PLANNING COMMISSION AGENDA CITY OF PRAIRIE VILLAGE TUESDAY, MARCH 4, 2014 7700 MISSION ROAD 7:00 P.M.

PLANNING COMMISSION MINUTES February 10, 2014

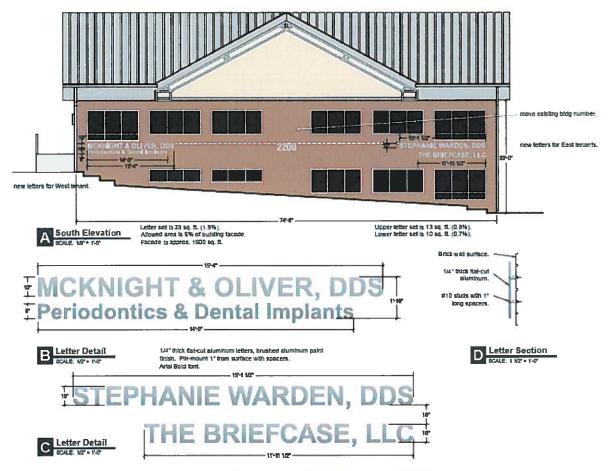
Staff has reviewed this proposal and it appears to be a reasonable solution for this particular building. If the Planning Commission approves this proposal, Staff recommends the following conditions be attached:

- 1. That the square footage for each sign not exceed the size that is shown on the attached drawing.
- 2. That the size of the sign letters be as shown on the drawing.
- 3. That not more than the three wall signs be permitted.
- 4. That no wall signs be permitted on the east, west and north facades of the building.
- 5. That the wall signs not be lit.
- 6. That the applicant revise the sign standard text and submit it to the City prior to obtaining a sign permit.
- 7. That the existing blade sign(s) be removed.

PC2012-113 Revised Site Plan for PV Shopping Center NW Corner 71st & Mission Road Zoning: C-2 Applicant: Kylie Stock, LegaC Properties

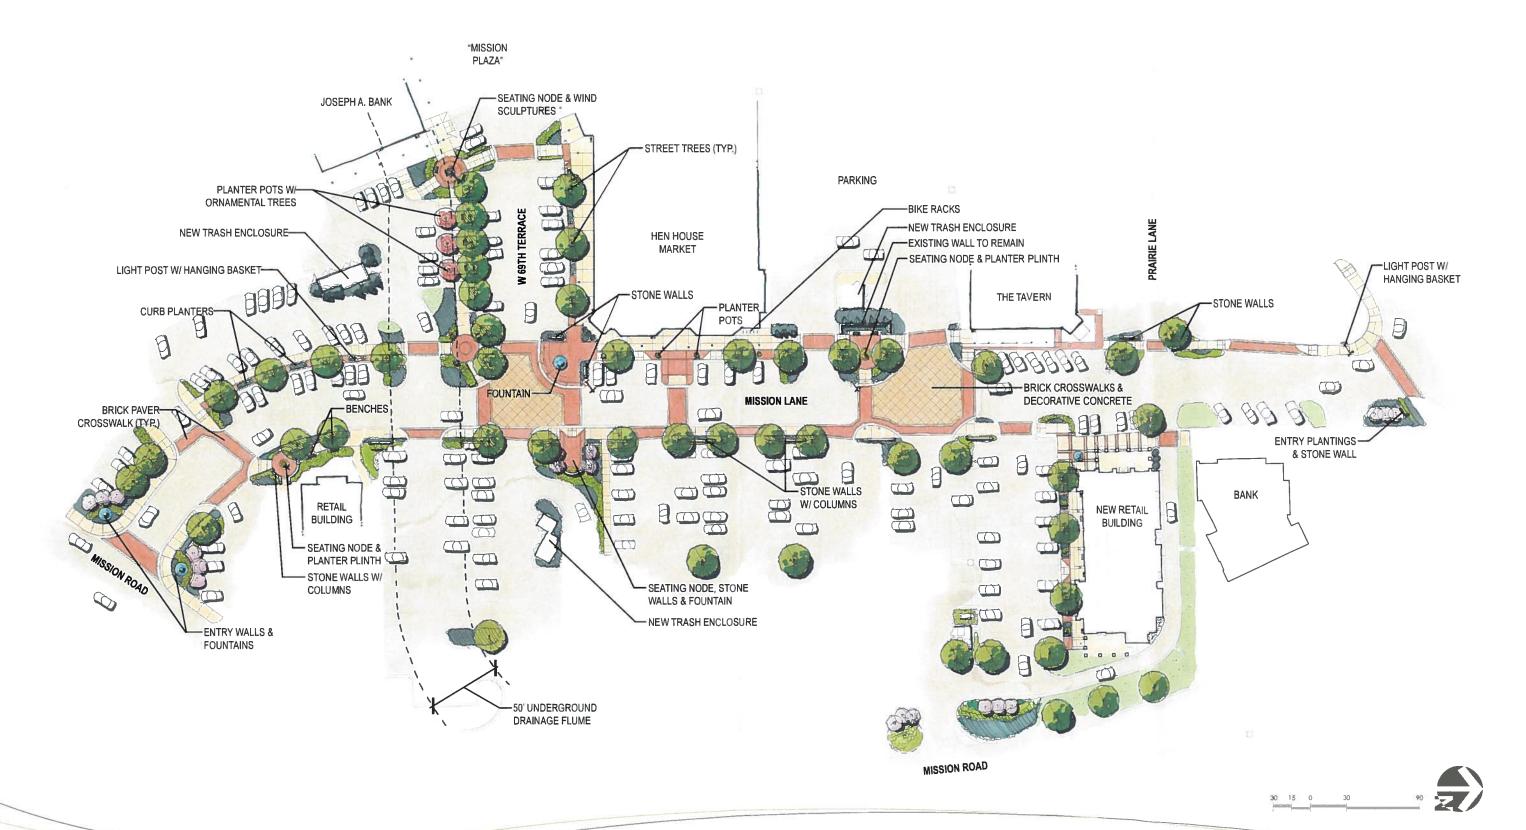
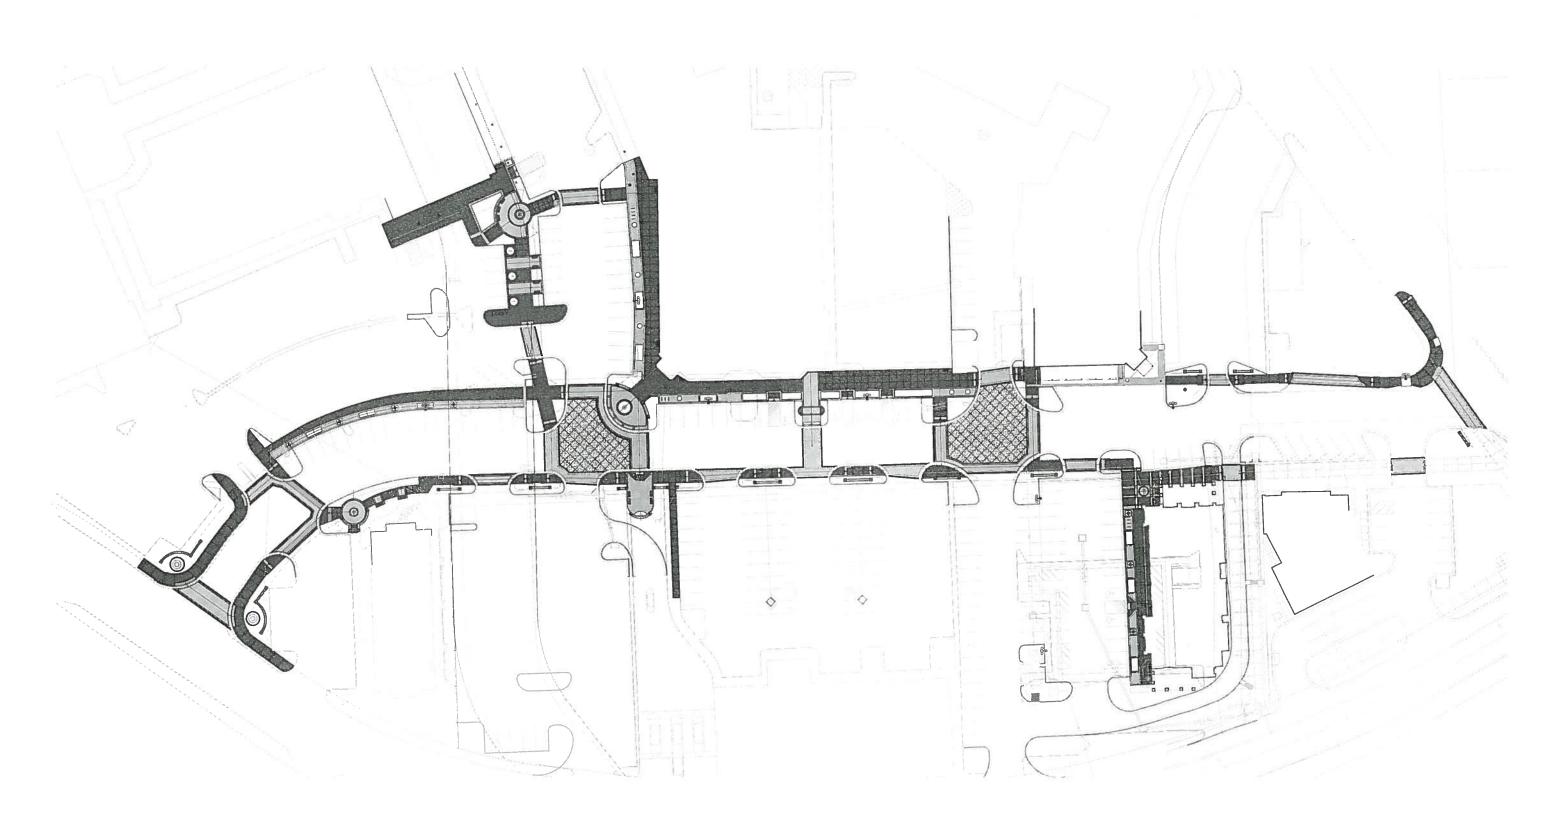
- 1. The footprint for the Hen House expansion will be removed and parking will remain on the north side of the store. The number of parking spaces in that lot will increase by 39.
- 2. The crosswalk will be moved south to the existing Hen House entrance.
- 3. The entrance and exit drives to the parking lot south of 69th Terrace will change back to where they are now. The Site Plan proposed to close the drive from Mission Lane and replace it with access to 69th Terrace. This reconfiguration will result in the loss of 12 parking spaces which results in a net increase of 27 parking spaces for the Center.
- 4. The applicants are also relocating several trash bin enclosures. The new trash bin locations will be screened with brick walls that match the brick in the Center.

The applicant has revised the off-street parking requirements table and the counts by lot on the Parking Analysis drawing; however, there may need to be additional revisions after Staff reviews the information in more detail.

The revised Site Plan will also change the landscape plan. The revised landscape plan needs to be submitted to the Tree Board for review and approval.

It is the opinion of Staff that the revised Site Plan removing the Hen House expansion and reconfiguring the parking lots will improve the traffic circulation and parking, and recommends approval subject to the following conditions:

- 1. That the applicant work with Staff to revise the off-street parking table and drawings for the Center, if necessary.
- 2. That the applicant submit the revised landscape plan to the Tree Board for review and approval.
